Access Compliance Report Public Rights-of-Way (Curb Ramps)

Main Street: RAINBOW_DR Cross Street: EVENINGSIDE_DR Location: SW

ADA ID: RPRK211006115605 Ramp Type: Type 1 - Perpendicular Diagonal Initial Pass/Fail: Fail Overall Compliance: No Severity Score: 16

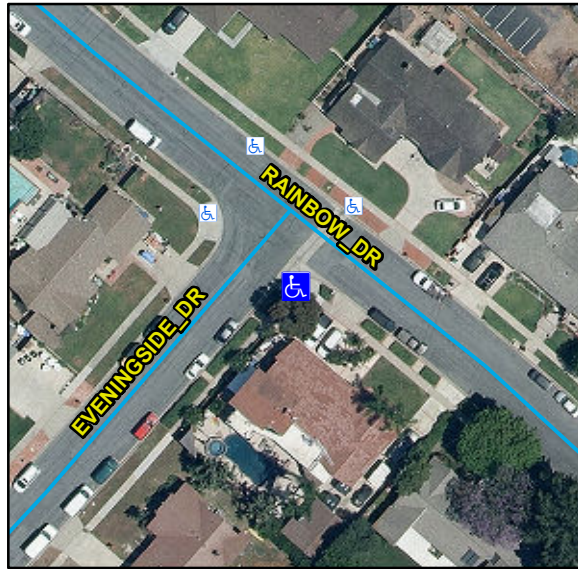
R304.2.2, R204.3, STD 1115

Remove & Replace Curb Ramp With Two New Directional Ramps or Equivalent.
